**70% PRELIMINARY DESIGN REPORT FOR
Ann Road Channel West – Rainbow Boulevard
CLV Hansen No. 36801**

**April 2011
Jacobs Project No. W4X53700**

Subject: Ann Road Channel West – Rainbow Boulevard Preliminary Design Report
(70%)

FIGURE D-3

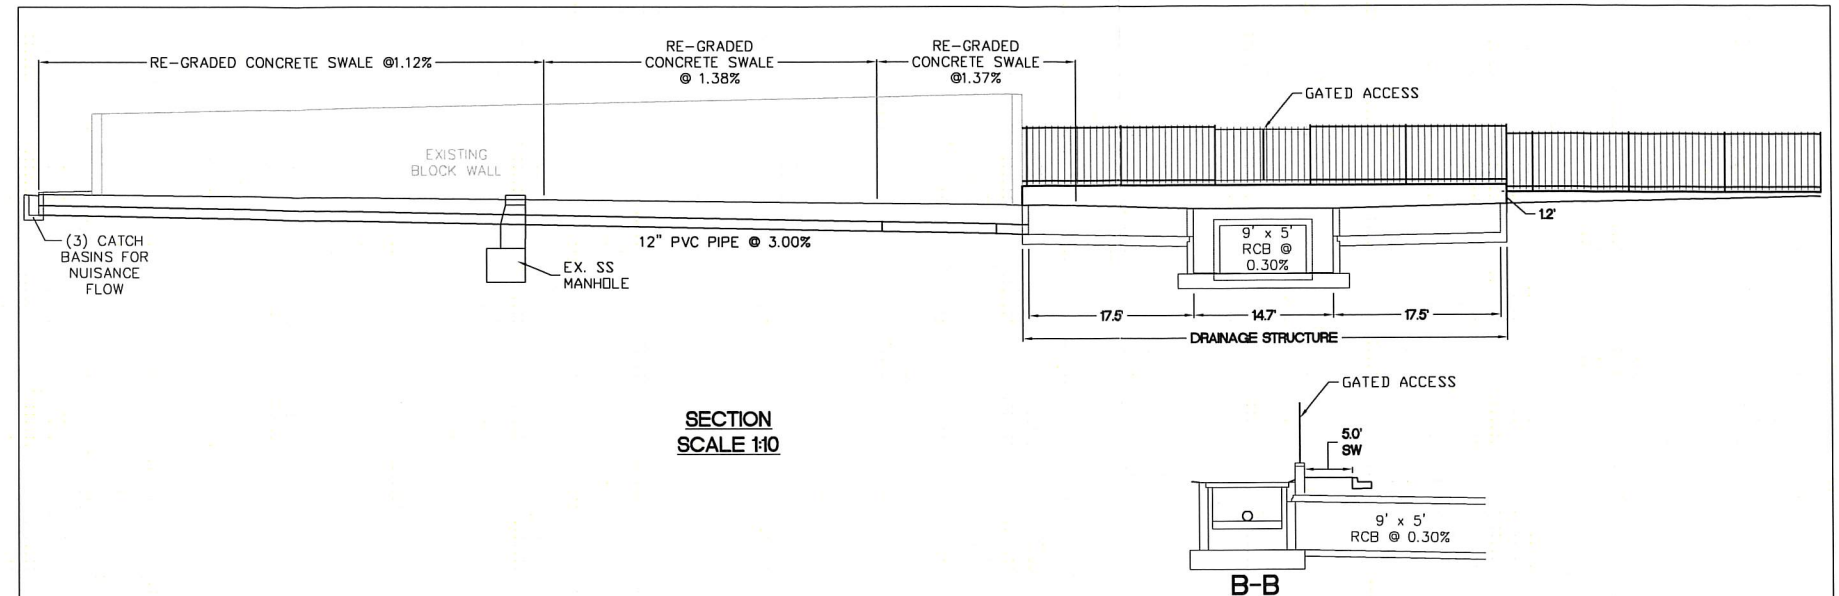
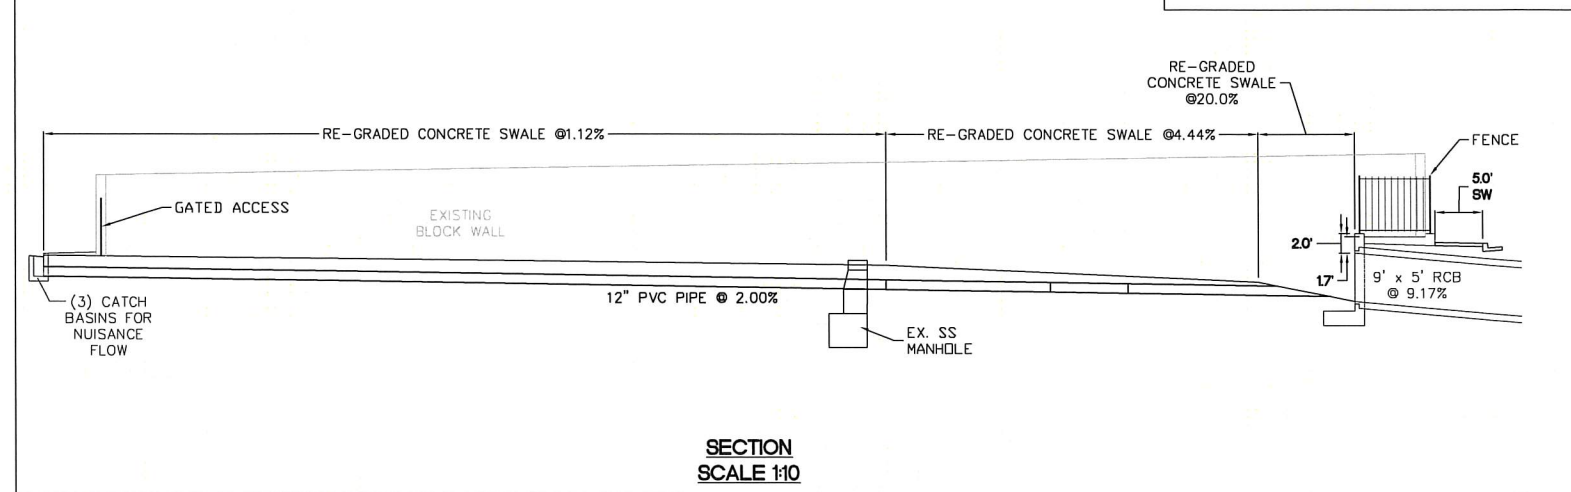
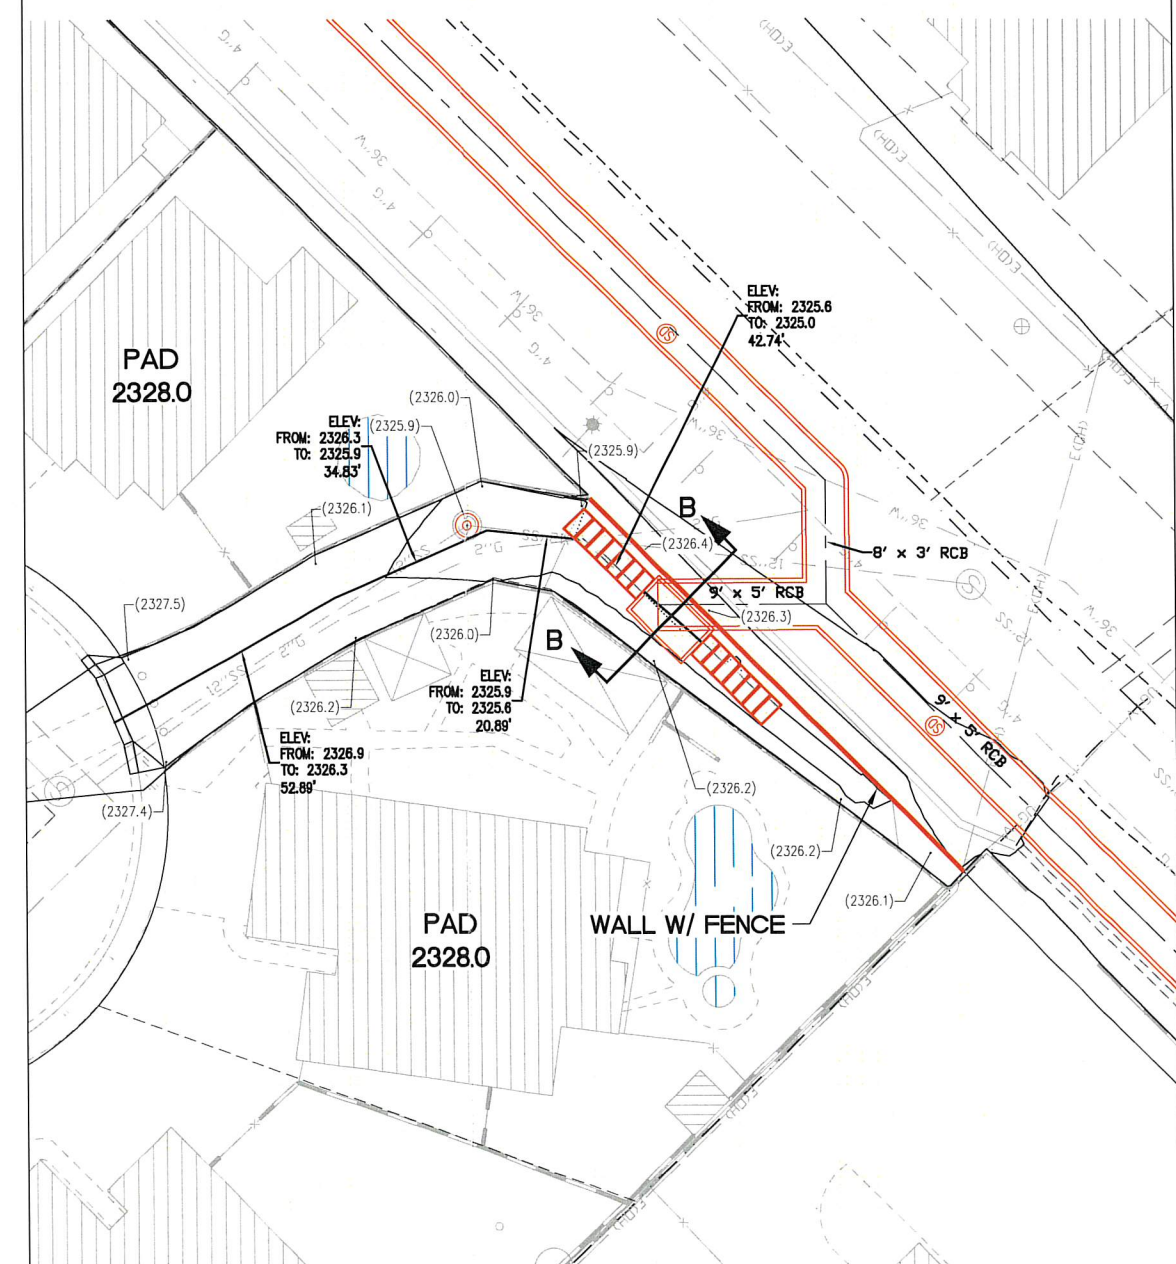
For an illustration of the drop inlets at the outlet of Rio Vista Estates, please reference Figure D-3, *Inlet Options*. According to the hydrologic analysis for this report, there is a 100-year runoff total of 239 cfs exiting from this location. As part of the original intent in this easement, a specialized set of inlets in a series at the downstream end of the easement were anticipated (See Option 2 of Figure D-3). As part of the original set of comments from the City of Las Vegas Flood control department, this system would also need one heavy duty grated structure with a minimum size of 10' X 7' which would

serve to provide maintenance access into the storm drain system. The grated structure would need to be mechanically lifted out of the way and then accessed by a maintenance crew. During the design process, an alternative solution for gaining access into the storm system while still allowing capacity for 239 cfs was considered (See Option 1 of Figure D-3). Option 1 will eliminate all inlets and the drainage structure channel will be graded to direct flow into headwall at a 9'x5' RCB. This was found to make gaining access into the storm drain much more efficient and eliminated the need for space to maneuver a heavy duty grate structure to access underground facilities. It was determined for this submittal that Option 1 will be utilized in the storm drain design.
